Turbocharger Wastegate Servo Cable Cooling**A. SUBJECT:**

Turbocharger wastegate servo cable cooling.

Fig. 1

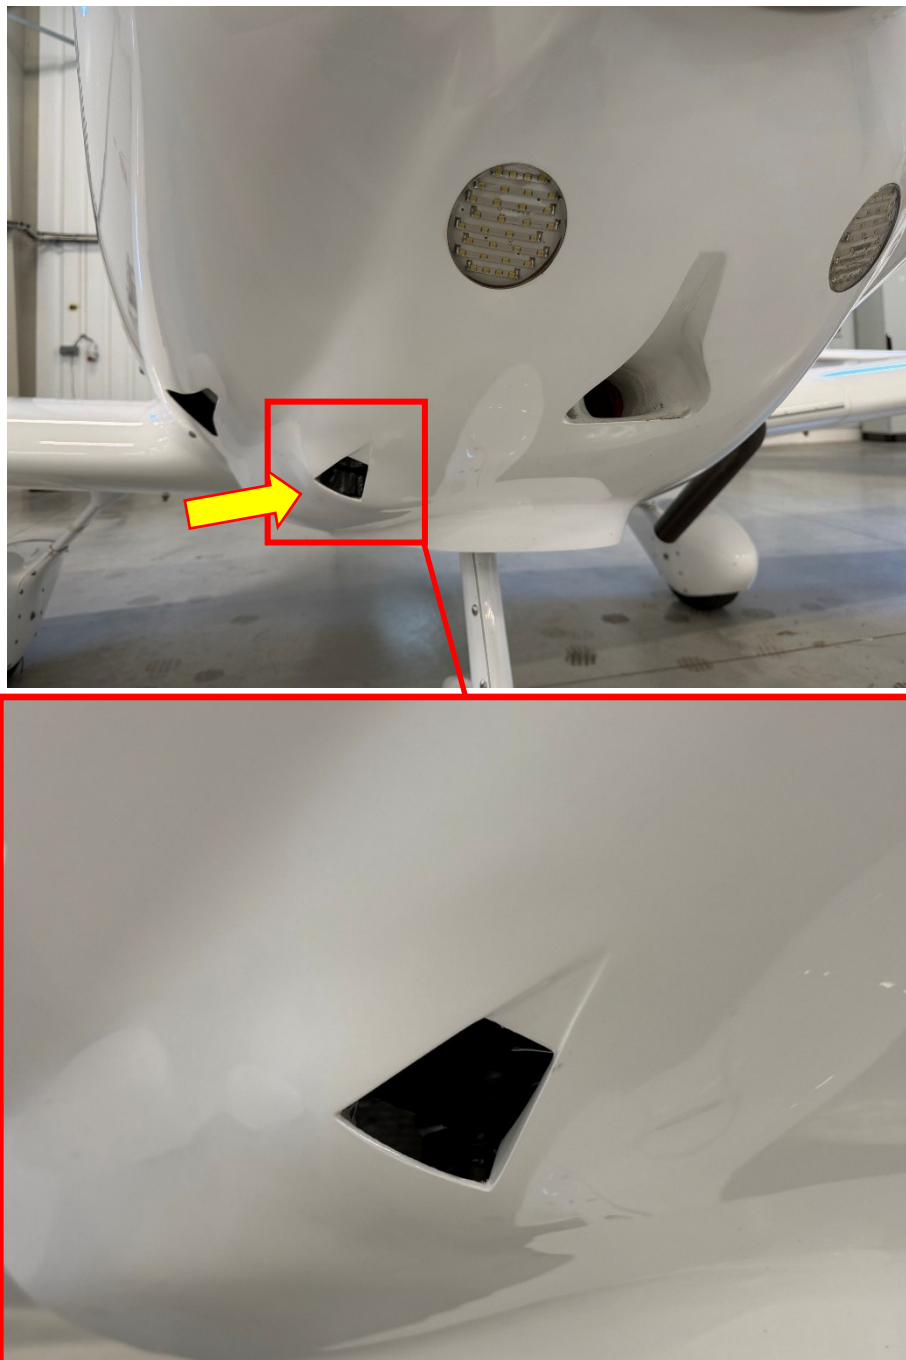
All aircraft equipped with engines Rotax 914UL from engine S/N 10003663 / manufactured after 23.10.2023, engines with installed turbocharger wastegate servo cables P/N 897940 or 897942, except of aircraft with already modified lower engine cowling with an opening for wastegate servo cables cooling (Fig. 1).

1. Check the wastegate servo cable for easy movement.
2. If **excessive friction is determined**, replace the wastegate servo cable with the new one according to Maintenance Manual for engine Rotax 914 Series and modify the lower engine cowling according to Service Instruction SI-2026-1 to improve the wastegate servo cable cooling.
3. If **no excessive friction is determined**, modify the lower engine cowling according to Service Instruction SI-2026-1 to improve the wastegate servo cable cooling.
